W3F1-2004-0095

SUBJECT: Supplement 3 to Amendment Request NPF-38-256,
Alternate Source Term
Waterford Steam Electric Station, Unit 3
Docket No. 50-382
License No. NPF-38

Response to Request for Additional Information

Figure 1

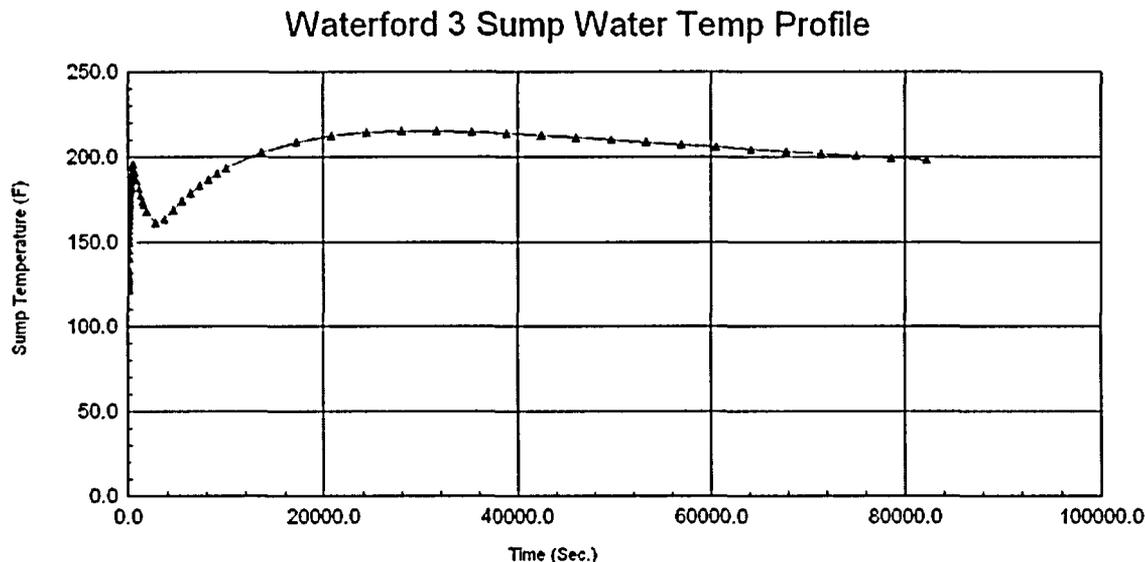
Page 12 of the September 1, 2004, supplement to the AST amendment request provides a constant enthalpy calculation of the maximum flashing fraction, based on the maximum ECCS fluid temperature. The filter shine dose analyses assumed a flashing fraction value of 2% based on the result of this calculation multiplied by a factor of 10. Section 5.5 of Appendix A of RG 1.183 states that for leakage with temperatures less than 212 °F or for calculated flashing fractions less than 10%, the airborne iodine should be assumed to be 10% of the total iodine activity in the leaked fluid, unless a smaller amount can be justified based on the actual sump pH history and area ventilation rates. Provide the justification for the lower flashing fraction value based on the actual sump pH history and area ventilation rates. Consider also the projected pH of the ECCS leakage and area ventilation rates for the DBA LBLOCA.

Figure 1 illustrates the projected sump temperature for EPU conditions for the first 24 hours. As shown in this figure, the maximum sump water temperature is 213.83 °F at 31,061 seconds. Also, the data used to generate Figure 1 states that the sump water temperature is above 212 °F for a short duration (roughly 5.28 hours to 12.3 hours). From 24 hours to approximately 11 days (1,000,000 seconds), the sump water temperature is approximated to linearly decrease to 165 °F and then remains constant at 165 °F for the duration of the accident (30 days). As shown in this figure, the maximum sump water temperature is 213.83 °F at 31,061 seconds which results in a maximum flashing fraction of ~0.2% as shown in the calculation below:

As shown in the calculation above and Figure 1, the maximum calculated flashing fraction is 0.2% based on a "maximum" sump water temperature. After 24 hours the sump water temperature is well below 212 °F (~197 °F) and remains well below that value for the duration of the LBLOCA. Therefore, it is very conservative (by more than an order of magnitude) to model a flashing fraction of 10% for the first 24 hours of the accident and then reduce the flashing fraction to a value of 2% thereafter. As shown below, the other criteria (sump pH and area ventilation) support this conclusion as well.

Figure 1 Control Room Emergency Ventilation Unit MicroShield Shielding Model

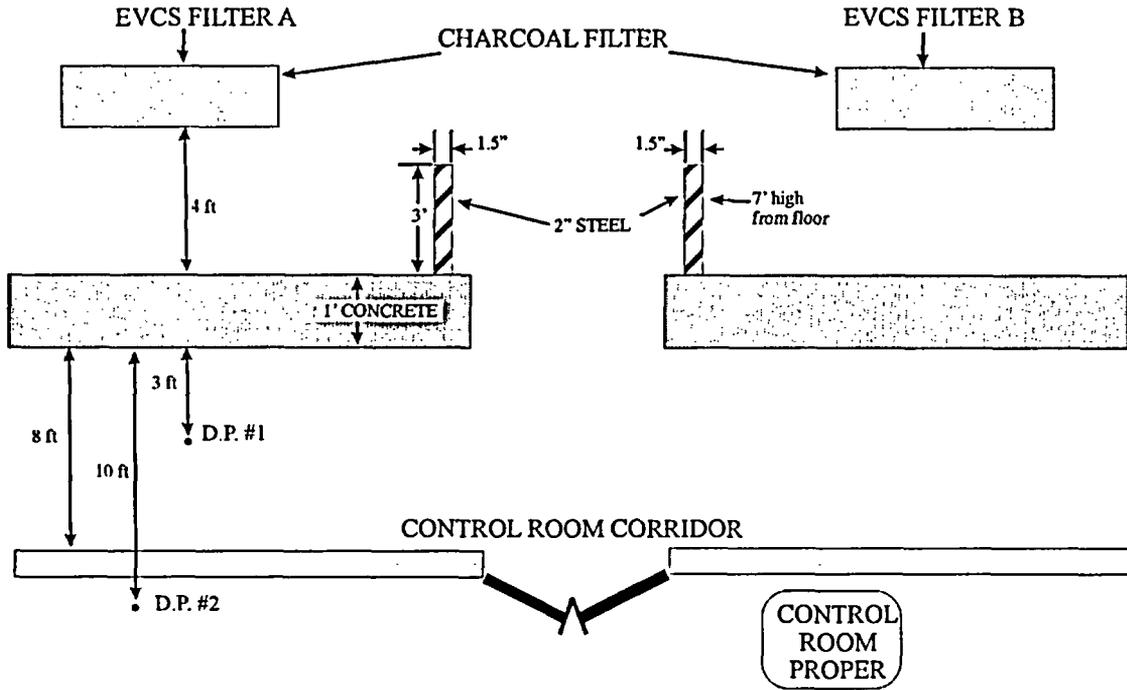
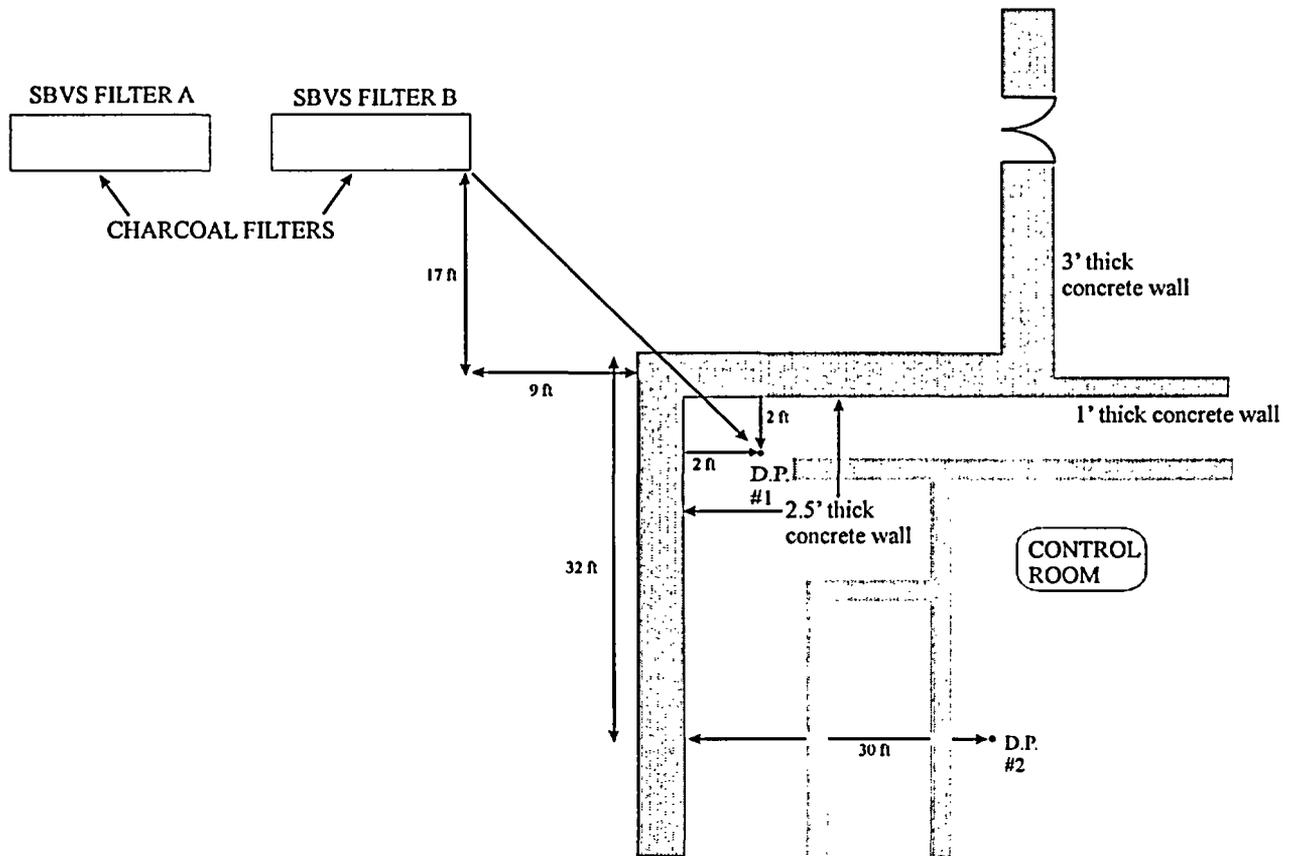
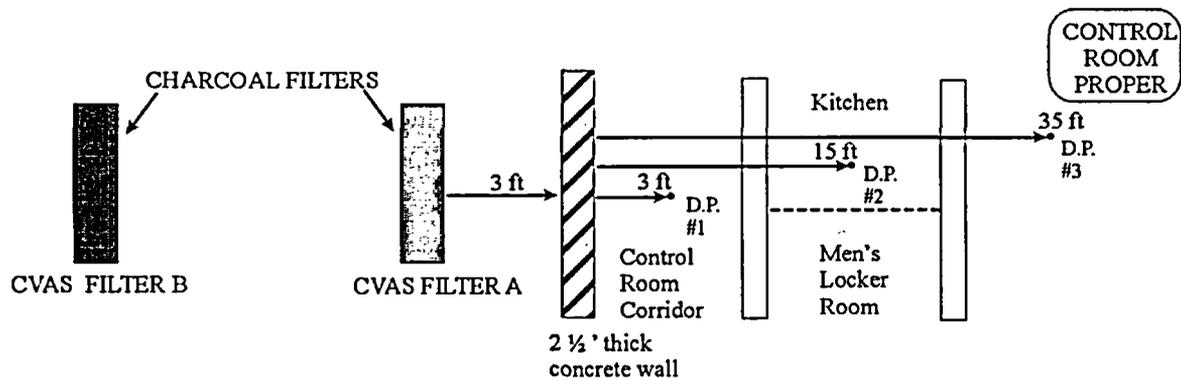
Provide assumptions and inputs for each of the shine dose analyses performed in MicroShield. This should include, but is not limited to, assumptions on shielding, geometry, source type and location and receptor location, along with their bases. Provide plant plans that identify the assumed shine sources and control room receptor point locations for the 3 filter shine dose analyses (shield building ventilation system, controlled ventilation areas system, and control room emergency air recirculation system), the direct containment shine dose analysis and the external plume shine dose analysis.

The MicroShield analyses credit a 1/4" thick steel thickness for all three filter housings. Table 1 below illustrates the charcoal filter design characteristics for each filter system that is assumed to be the source for the MicroShield calculations. Control room occupancy factors from RG 1.183 are used to calculate the integrated dose in the control room from the filter shine calculations. Figure 1 illustrates the dose geometry for the Control Room Emergency Ventilation filters. Figure 2 illustrates the dose geometry for the SBVS filters. Figure 3 illustrates the dose geometry for the CVAS filters. Tables 4-7 in response to Question #19 represent the source terms deposited on the various filter systems discussed above.

As shown in Figures 1-3 below, the doses were reported for dose points located in the MCR near the operations panels where the operators would actually be stationed, not just inside the walls defining the control room envelope (i.e., including the corridor surrounding the MCR).
